RE: LINDT FACILITY PROJECT (SSD 14-6620) – SECTION 96 MODIFICATION (MOD 2) – STATEMENT OF ENVIRONMENTAL EFFECTS

**ATTACHMENT 1:
REVISED SITE/FLOOR PLAN**

Figure 3: Site Plan – As Approved

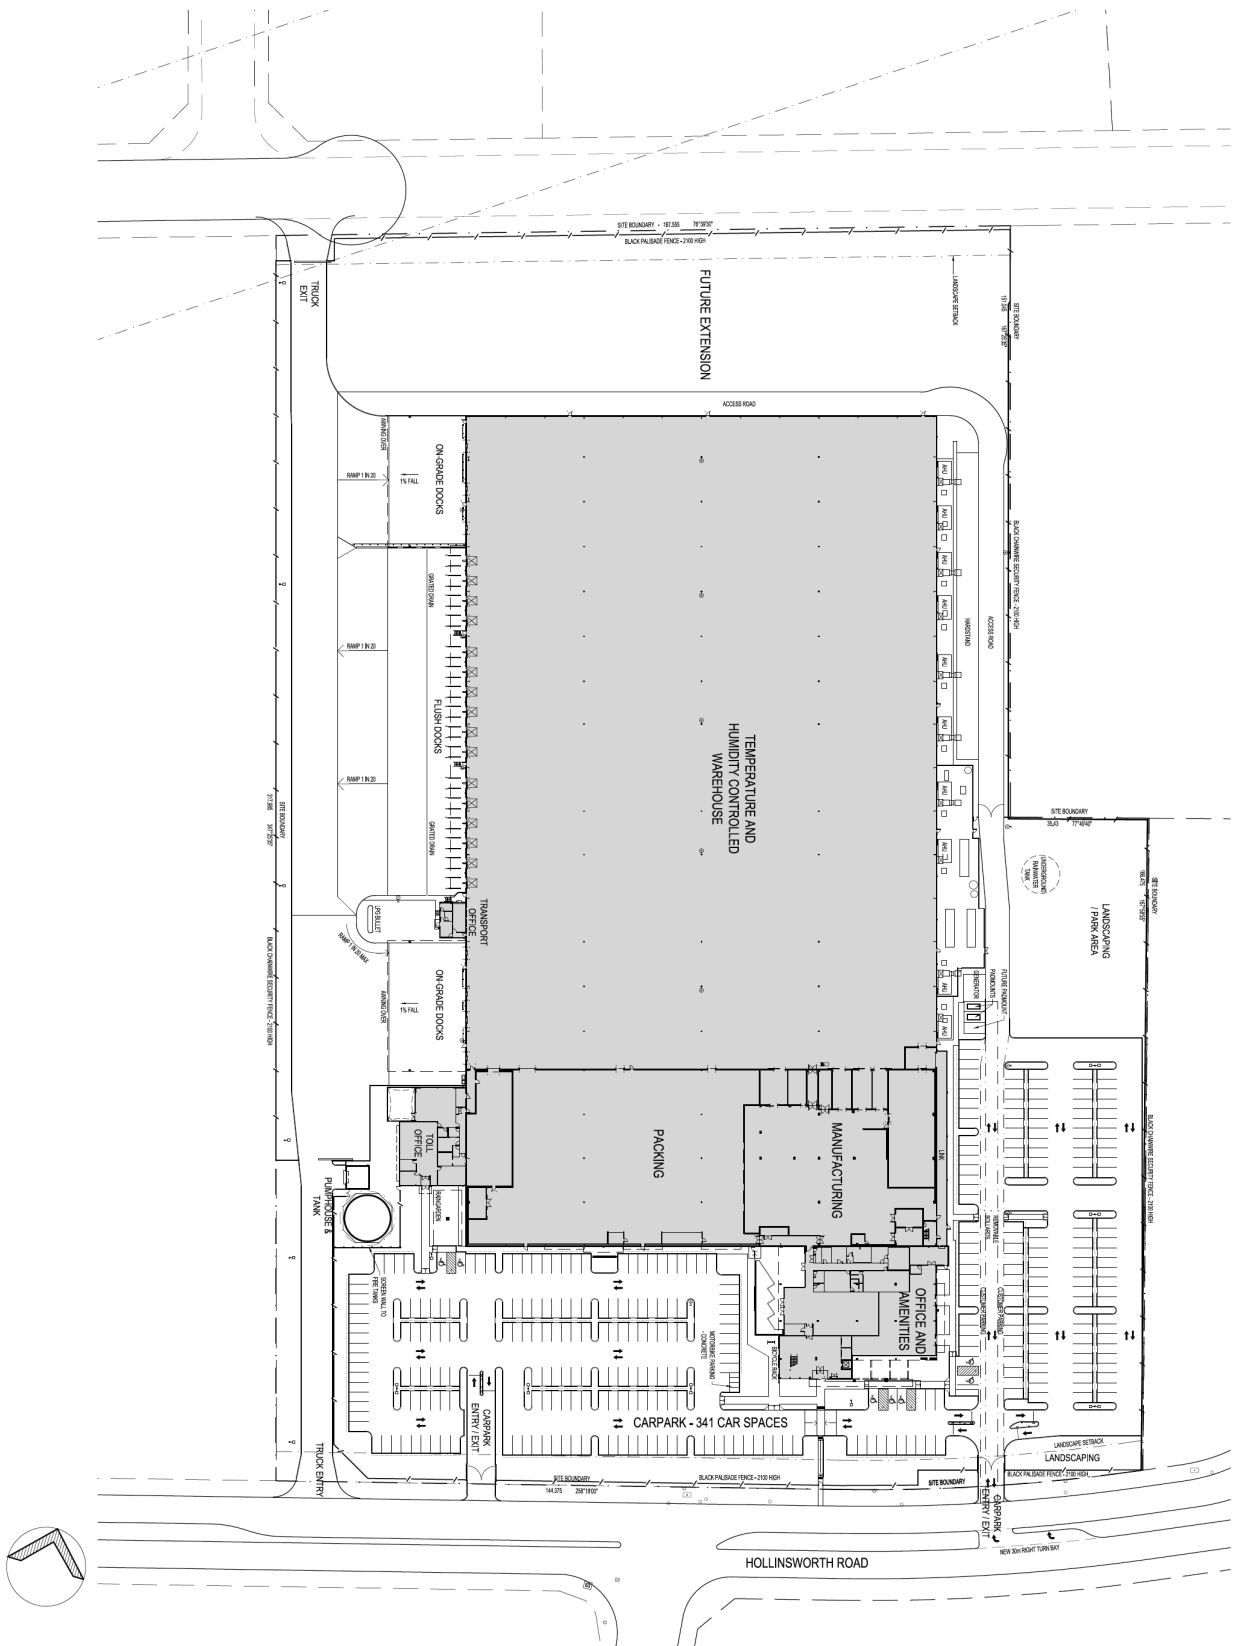
The layout of the facility as approved is shown in **Figures 3 and 4**, and is described in detail in the Environmental Impact Statement (EIS) for the project dated August 2014.

Figure 5: Site Plan – As Proposed

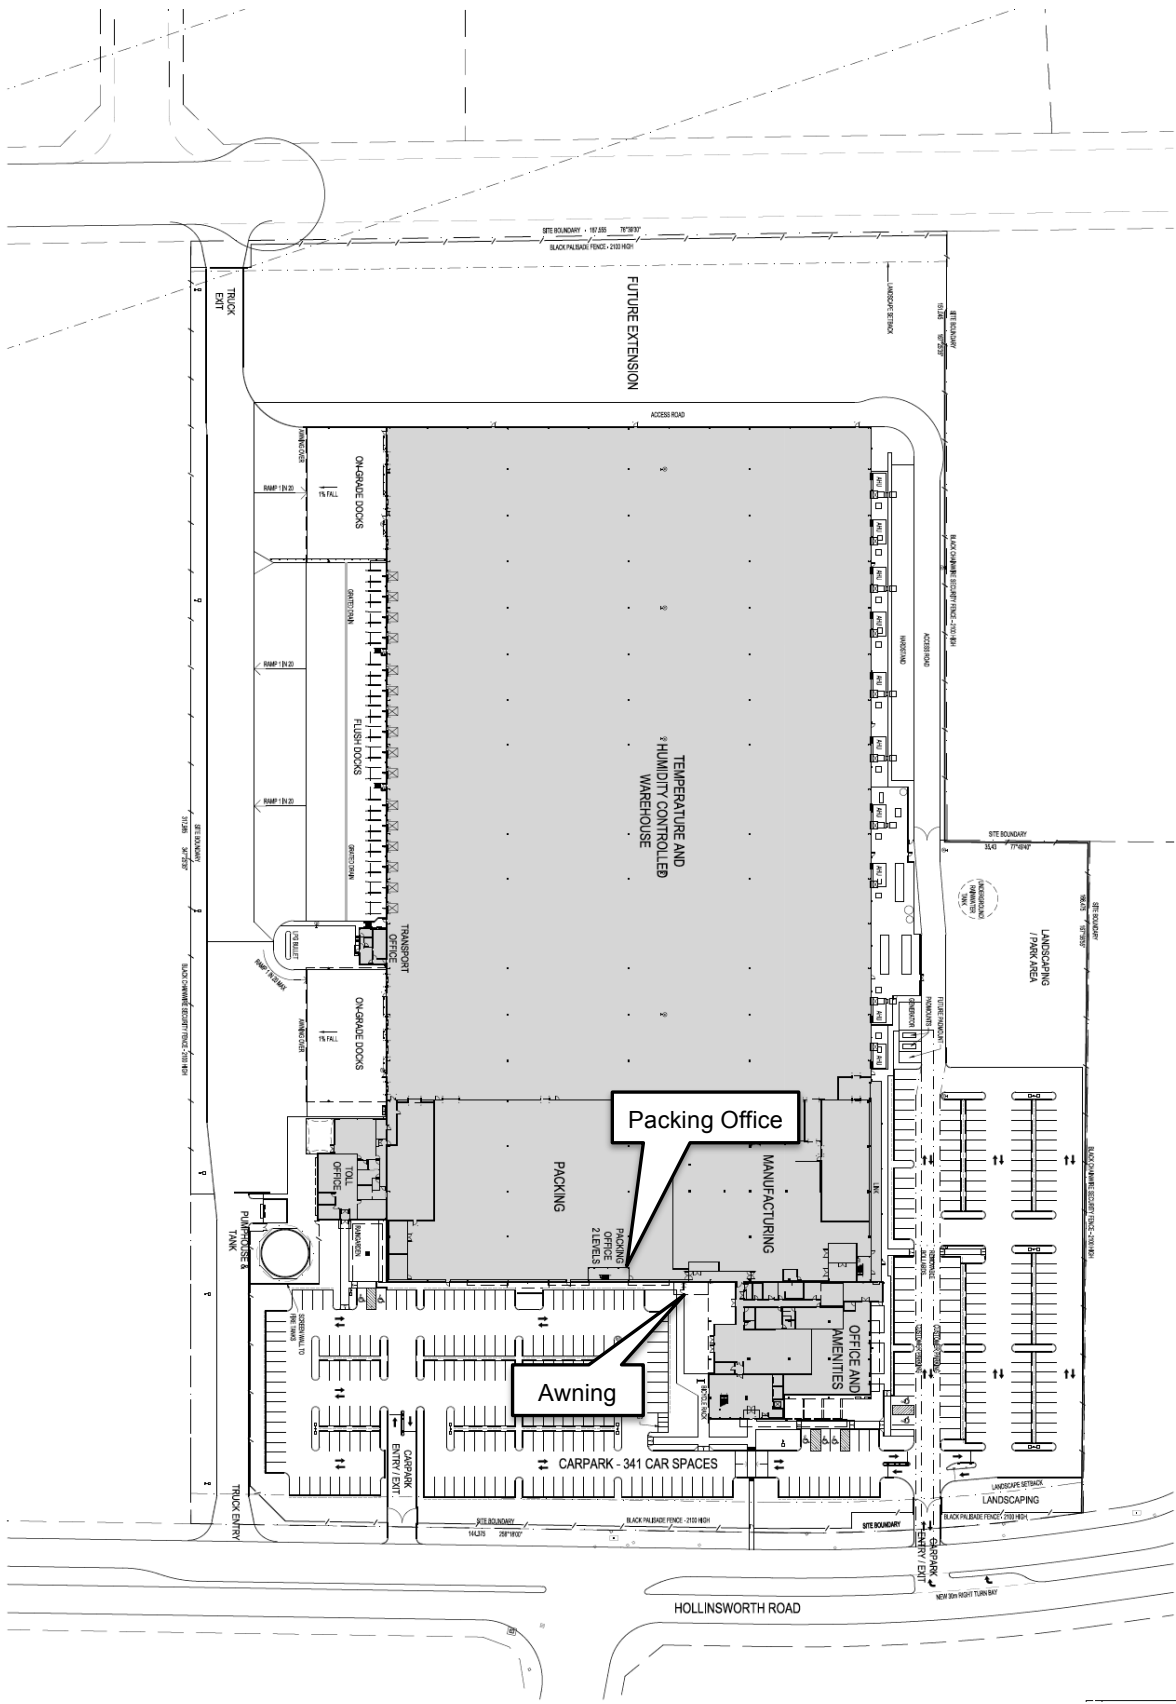
The proposed changes to the Lindt Facility are shown on **Figure 5**, and include:

- *new ancillary office within the packing area* – a 2 level internal office is proposed to be added to service the packing area. The office would have a floor area of approximately 70m², comprising 30m² on the ground level and 40 m² on a mezzanine level. The ancillary office does not involve any external alterations to the facility; and
- *minor change to the awning over the staff outdoor area* – a small increase in the size of the awning over the staff outdoor area on the western side of the main ancillary office is proposed to increase staff amenity. The change would increase the awning size by 40m² (ie. from 1,800m² to 1,845m²).

TITLE
SITE / FLOOR PLAN

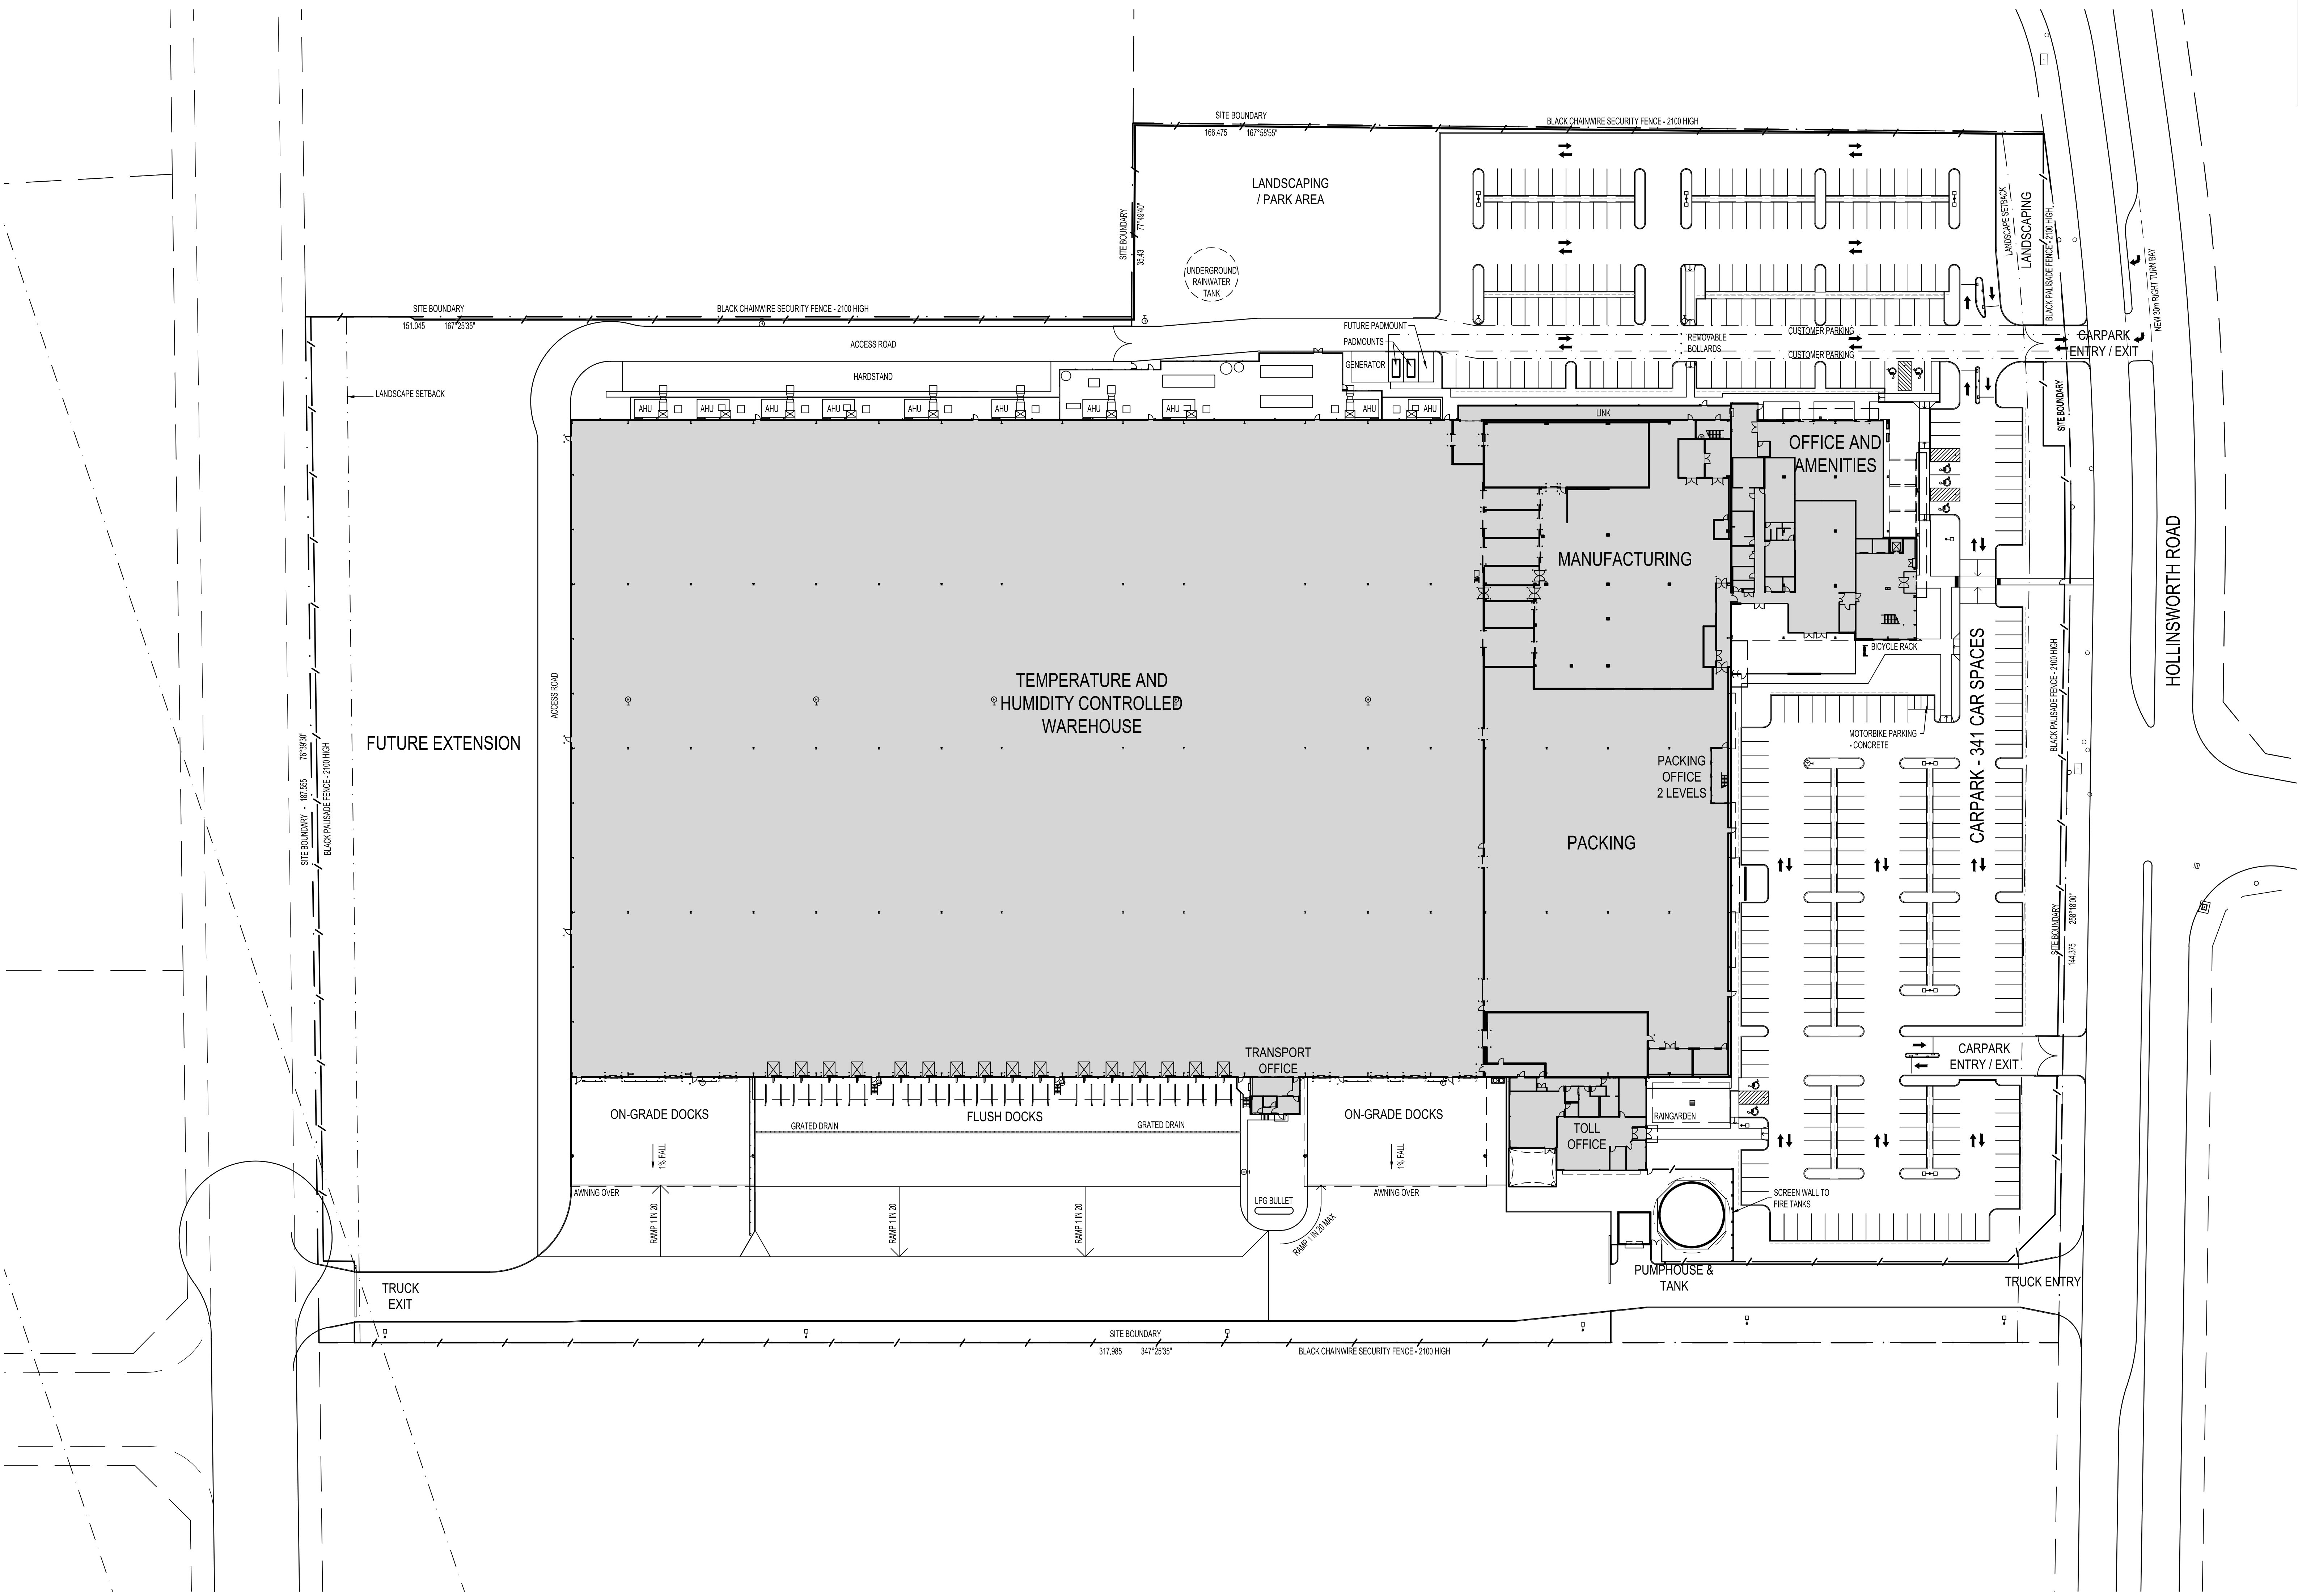
REV.	DATE	AMENDMENT	SIGNED
D	29-07-15	PACKING OFFICE UPDATED	JTC
C	29-04-15	ISSUED FOR SECTION 98	JTC
B	25-07-14	CARPARK ISLANDS UPDATED TO MATCH CIVIL DESIGN	JTC
A	10-07-14	ISSUED FOR DEVELOPMENT CONSENT	JTC
